**State of New Mexico
General Services Department
Purchasing Division
(505) 827-0472**

Amendment No. **Two**

Re: Invitation to Bid Number: **50-52100-25-06151**

Title: **Madrid Stormwater and Erosion Control Project**

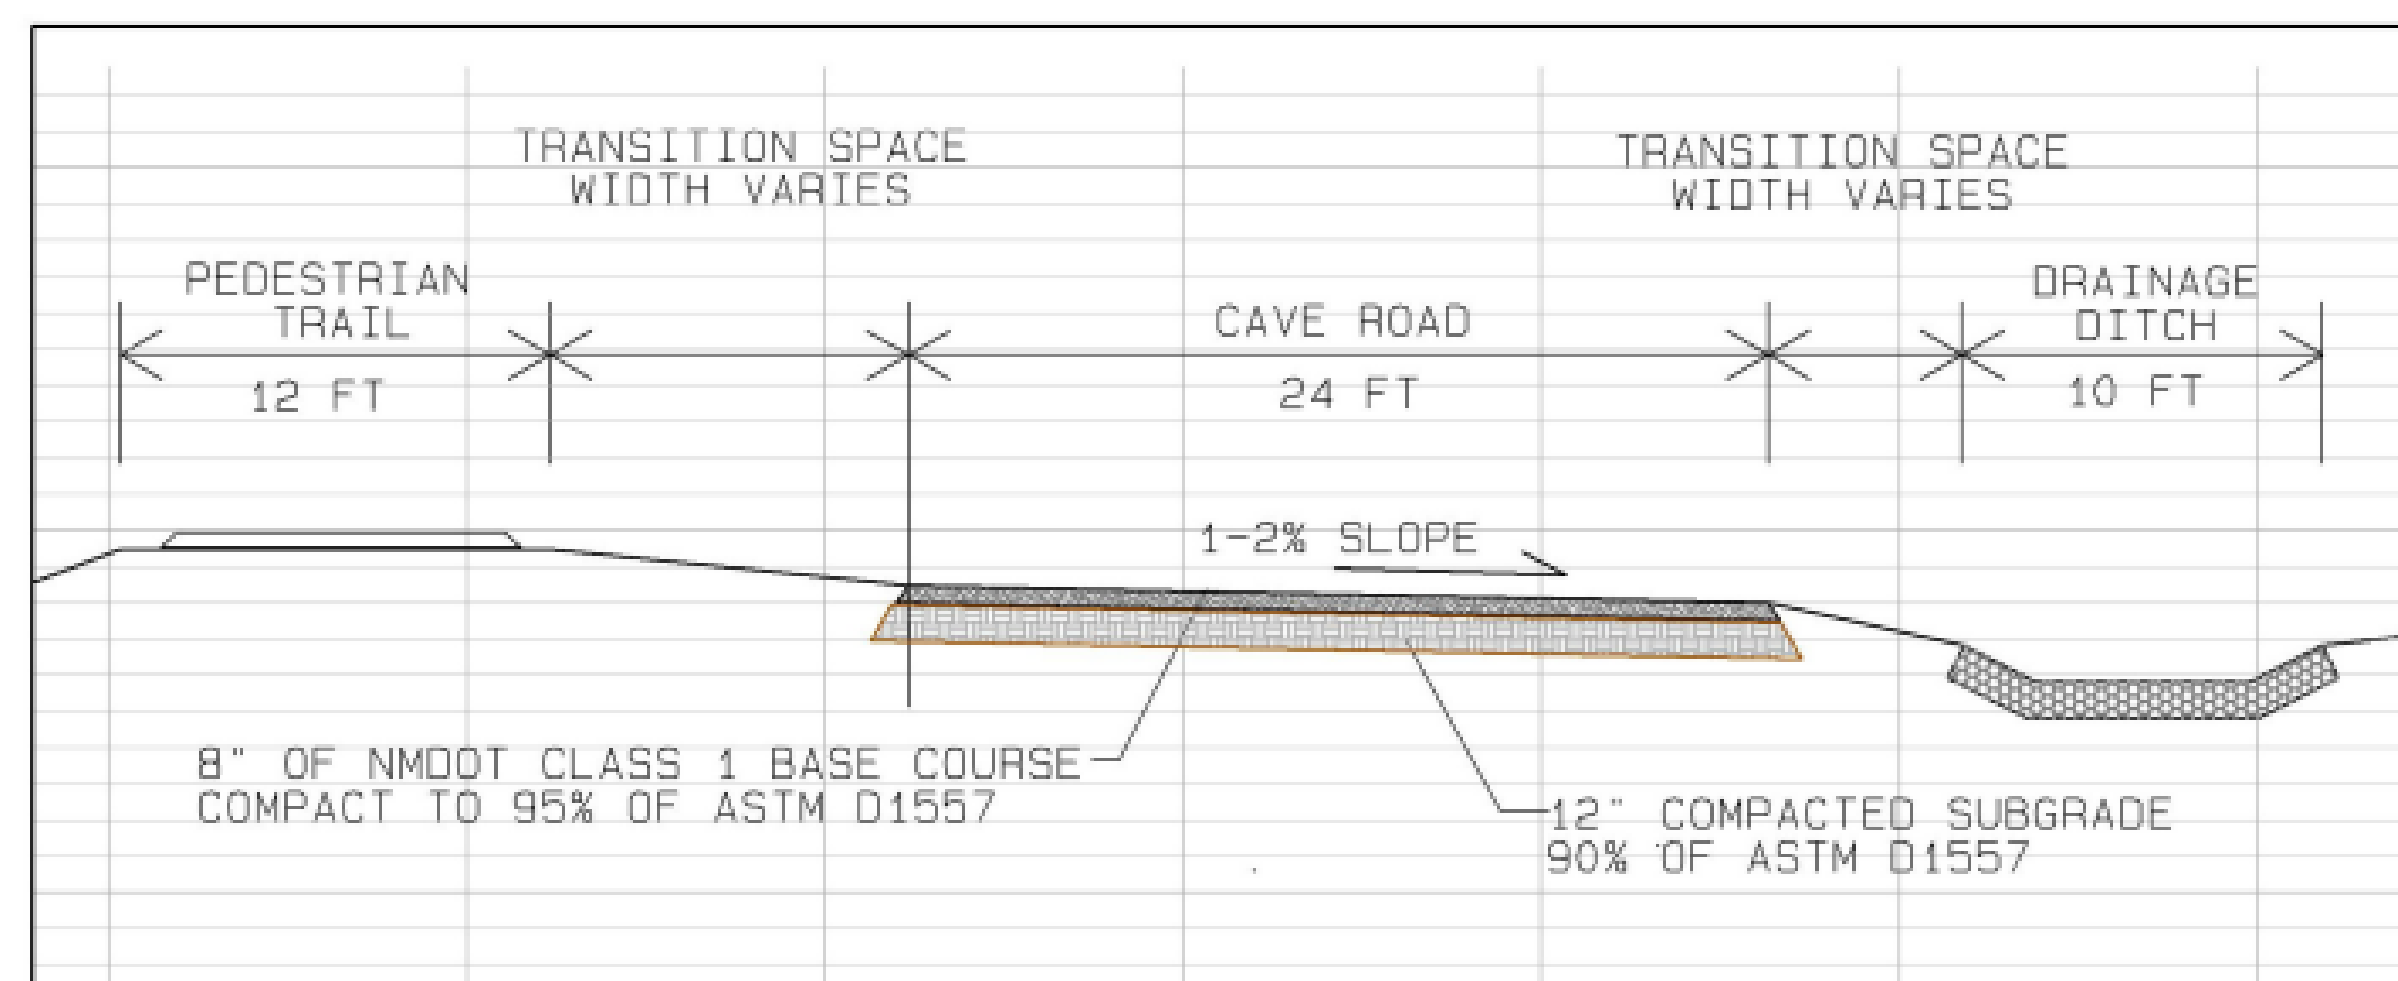
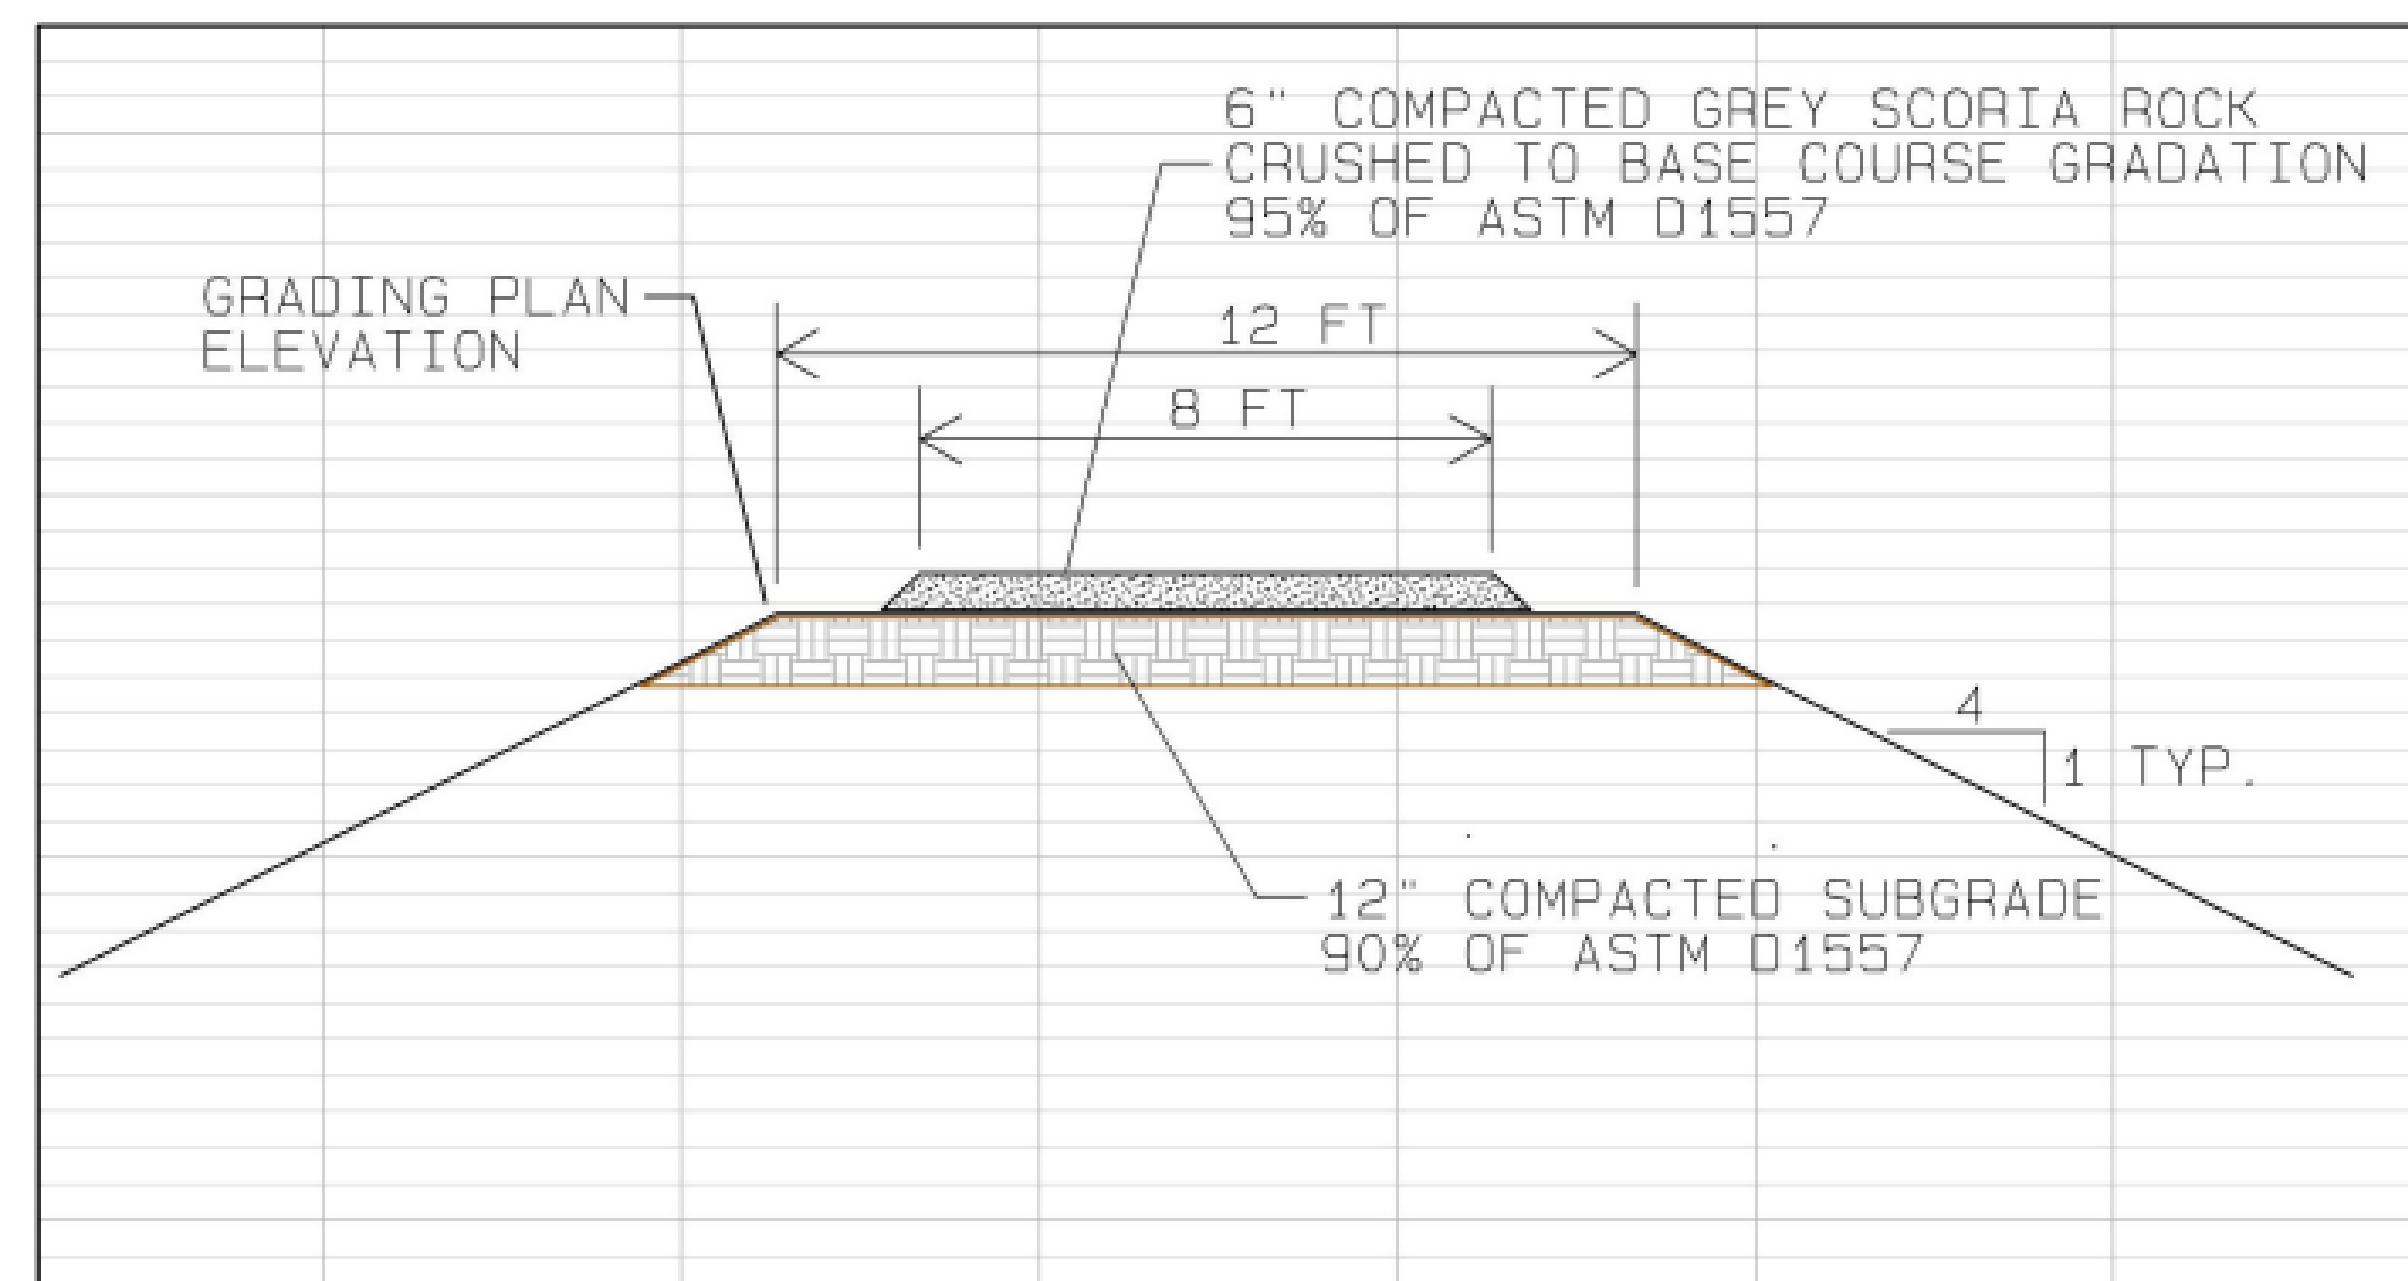
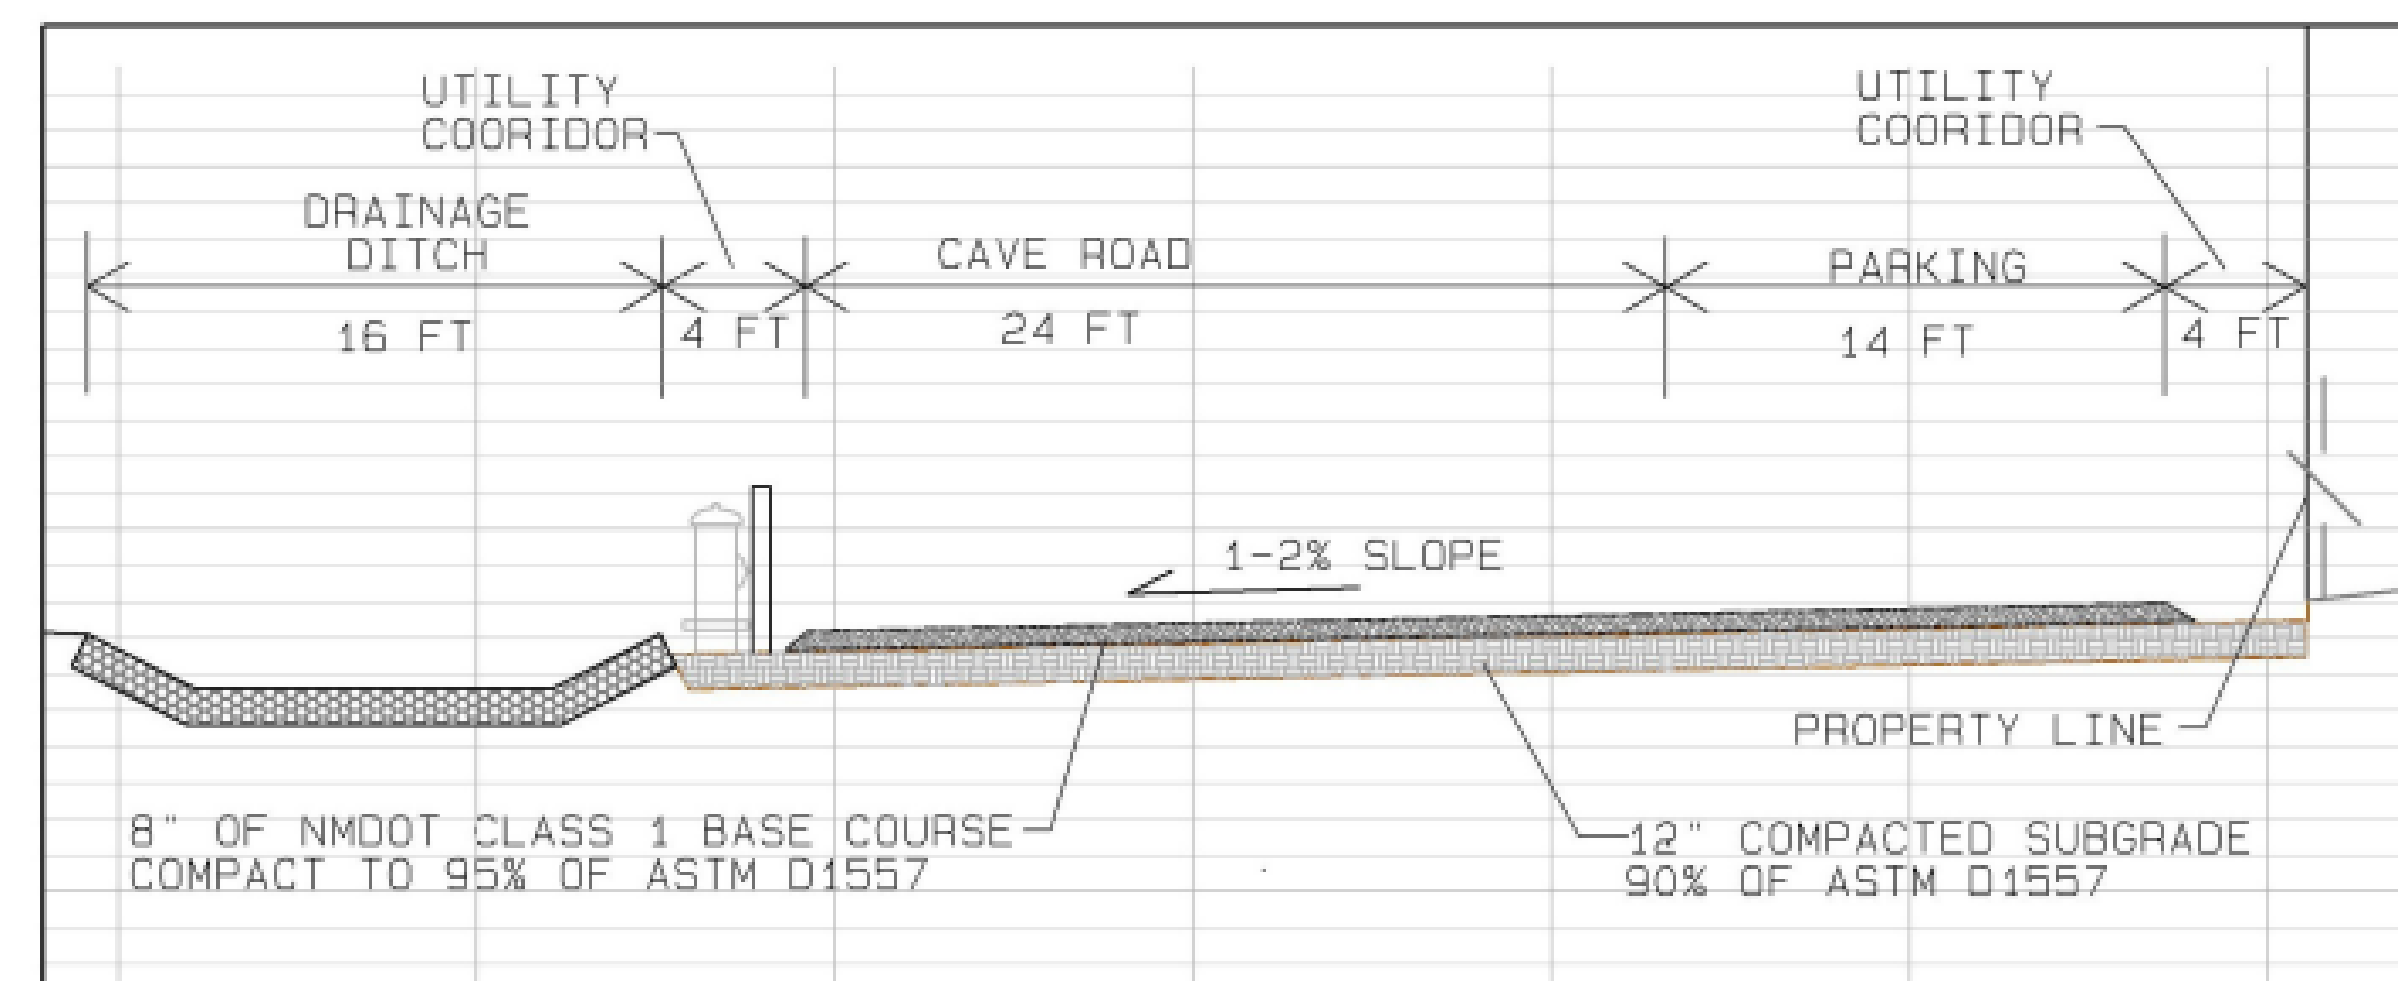
- 5.) **Western Technologies Final Geotechnical Report (66 pages, Attached Below)**
- 6.) **Page C217 on the for-bid drawing set did not print correctly. This page was printed as a duplicate of page C219 on the published version of the bid-set for unknown reasons. Please see the attached sheet as C217 (1 page, Attached Below)**
